USC Reference: USC119
Council Reference: MCU26/0031

INFORMATION REQUEST RESPONSE 177-179 FRANCIS STREET WEST END

RESPONSE TO TCC INFORMATION REQUEST 177 FRANCIS STREET, WEST END TCC APPLICATION NO: MCU26/0031

**RESPONSE TO SARA ADVICE NOTICE – 177 FRANCIS STREET, WEST END
QUEENSLAND
SARA Reference: 2605-52145 SRA**

1 site plan
1 : 150

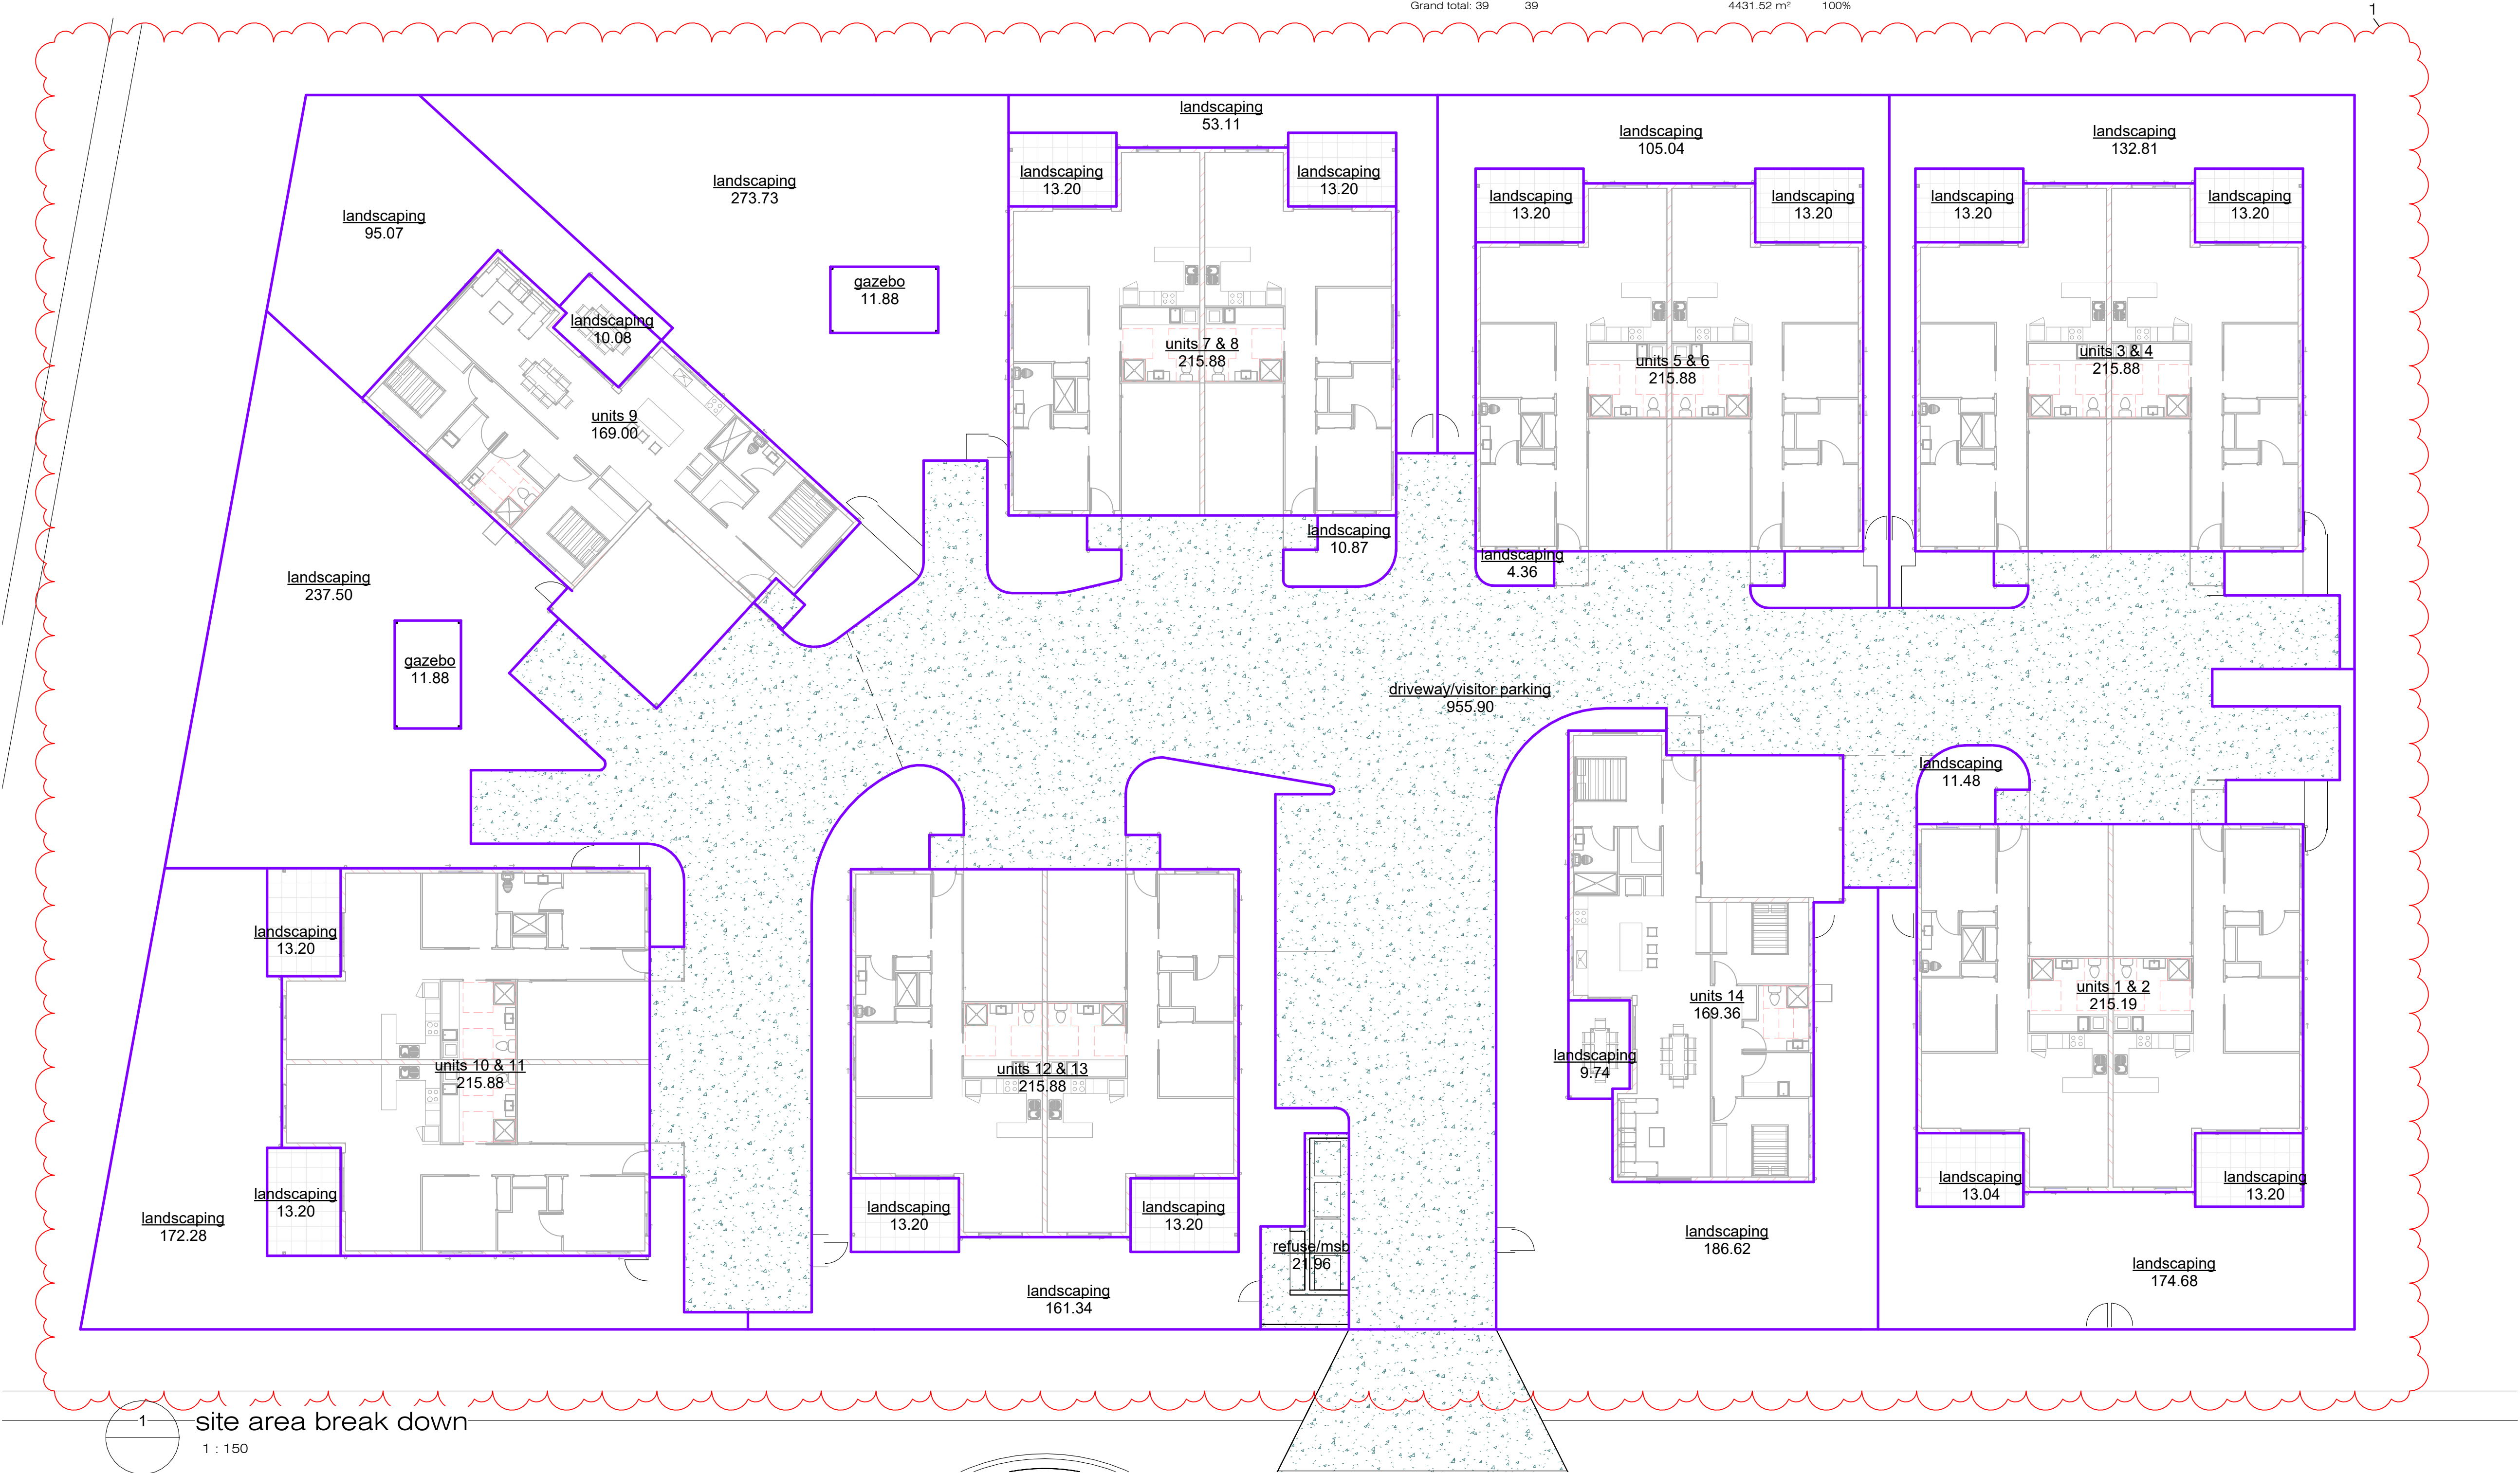
The applicant is requested to provide a revised parking layout that relocates and/or alters proposed spaces 4, 5, 10 and 11 so that all parking spaces are situated in accordance with the relevant standards.

The applicant is advised that the four spaces mentioned above are currently located at the end of blind aisles, requiring an unsafe and inconvenient lengthy reversing manoeuvre to enter and/or exit the spaces.

The applicant is requested to provide an amended layout such that all new buildings and/or structures (including roof overhangs) will be located with a minimum 2m horizontal separation to the outer edge of the trunk sewer pipe that runs diagonally through the site.

The amended suite of plans have redesigned the development, and resulted in a net loss of two carparking spaces, refer **Attachment 1**. A swept path analysis has been provided for carparking spaces 4 and 5, refer **Attachment 2**.

The amended suite of plans have been prepared and are provided in **Attachment 1**, addressing all matters raised and to meet compliance with Item 2.

The amended suite of plans have been prepared and are provided in **Attachment 1**, providing a pathway along the entire Francis Street frontage and a connection to Percy Street. At this stage, RPEQ certified drawings and detailed engineering design have not been completed; these documents can be required as a condition of approval, with certification by a Registered Professional Engineer of Queensland can meet relevant standards prior to construction.

Figure 2.4 – TCC Flood Modelling 1% AEP

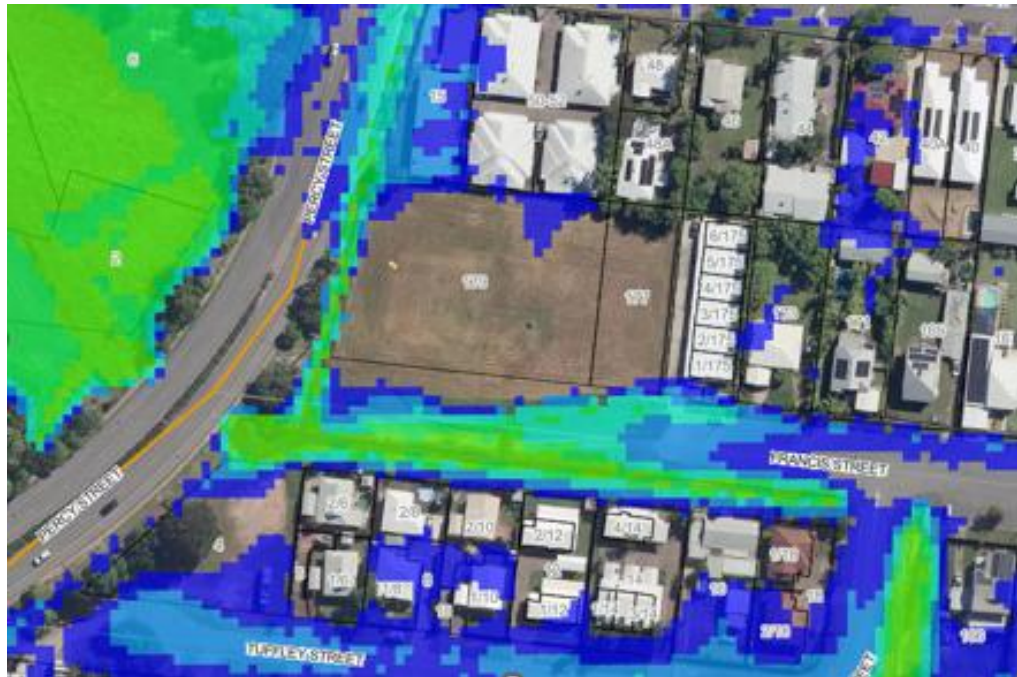
b) Provide an analysis demonstrating the downstream receiving stormwater system has sufficient spare capacity for minor and major events to receive the increase in runoff due to the development whilst achieving QUDM requirements.

The Townsville Flood Mapping confirms that the 1% AEP rain event is contained in the Percy and Francis Street road reserves, confirming the DTMR designed culverts have sufficient capacity to convey flows up to the 1% AEP event.

The culverts under Percy Street discharge stormwater runoff from a catchment that contributes to Munday Creek. To further demonstrate that the proposed development will not have an impact on the Percy Street culverts, we have provided (Attachment A) the catchment plan, time of concentration and hydraulic inputs for the culvert to demonstrate the culvert has sufficient capacity to cater for all rainfall events up to and including the 1% AEP.

Figure 4: Predicted Year 2036 Traffic Noise Levels – Ground Level (Façade Corrected)

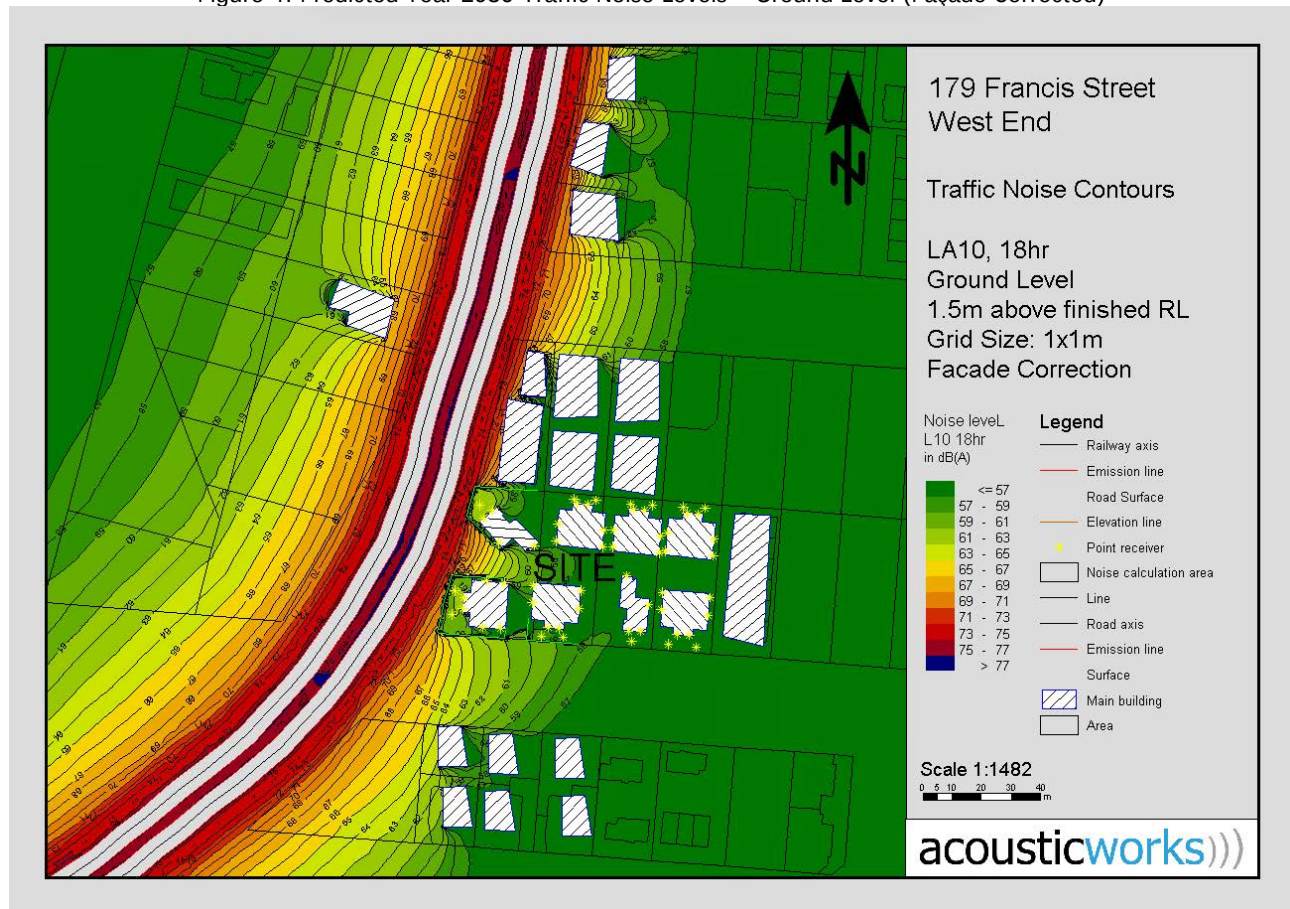
- b) Revise the assessment contained in Section 7.3 and Figure 4 (of the Acoustic Report, prepared by Acousticworks, dated 25 March 2026) to address the predicted exceedances of the 60 dB(A) freefield noise criterion within the ground level private open space areas of Units 9, 10 and 11.*

A revised road traffic noise assessment has been conducted, based on updated monitoring, to determine compliance with free field criterion for all outdoor private areas. To achieve predicted compliance, acoustic barriers for the affected lots 9 to 11 have been increased from 2.0m to 2.4m. Based on the updated acoustic treatments, revised L10,18hr predictions and corresponding noise categories have also been provided in Table 10.

Figure 5: Predicted Year 2036 Traffic Noise Levels – Ground Level (Free Field)

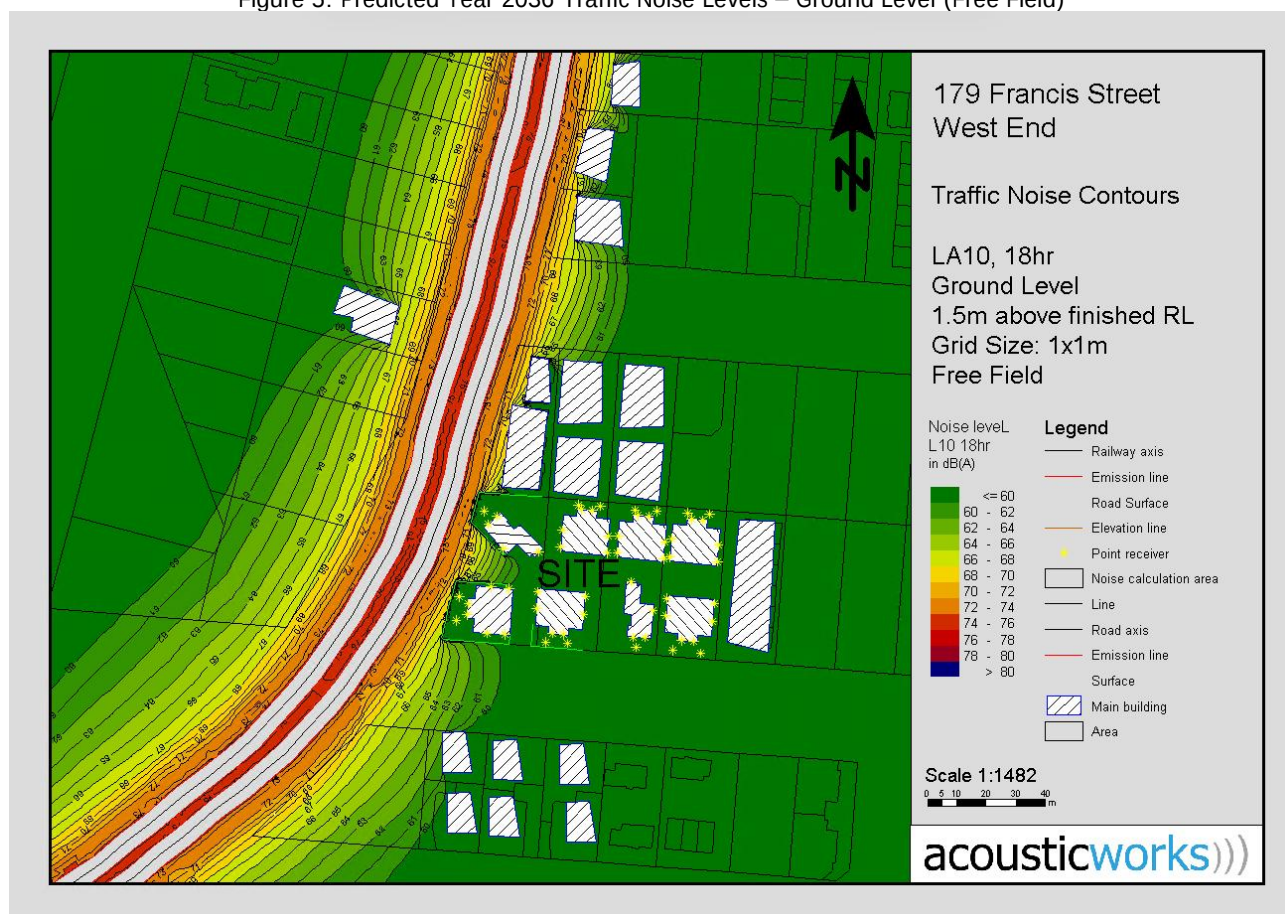
- c) Provide revised noise contour plots that clearly identify the 60 dB(A) free-field noise contour line, as the current contour plots do not enable clear verification of compliance with the applicable criterion.*

Figure 5 has been revised based on updated treatment requirements. The noise contour shows predicted compliance with 60dBA free field requirements.

Based on the updated acoustic treatments, compliance for all areas of the outdoor passive areas is predicted and demonstrated in Figure 5 and 6.

Figure 6: Predicted Year 2036 Traffic Noise Levels – Ground Level (Free Field) lots 9-11

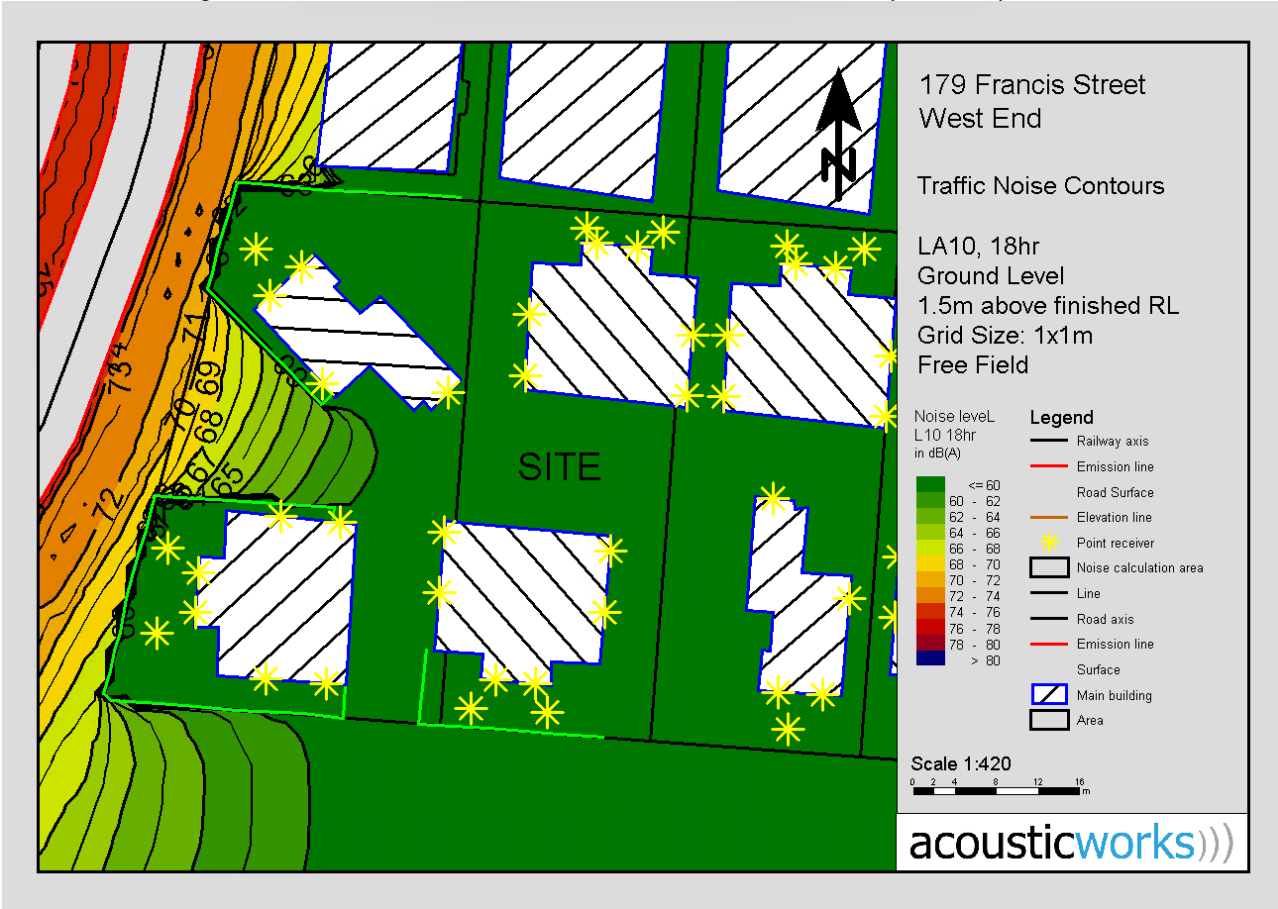
- d) Provide detailed and zoomed-in noise contour plots for Units 9, 10 and 11, including any proposed acoustic mitigation measures such as noise barriers, to clearly demonstrate compliance with the 60 dB(A) free-field noise criterion across all private open space areas.*

An additional noise contour figure has been provided to show predicted compliance for lots 9 to 11. This figure provides a zoomed-in plot which shows the acoustic barrier locations and noise contour compliance.
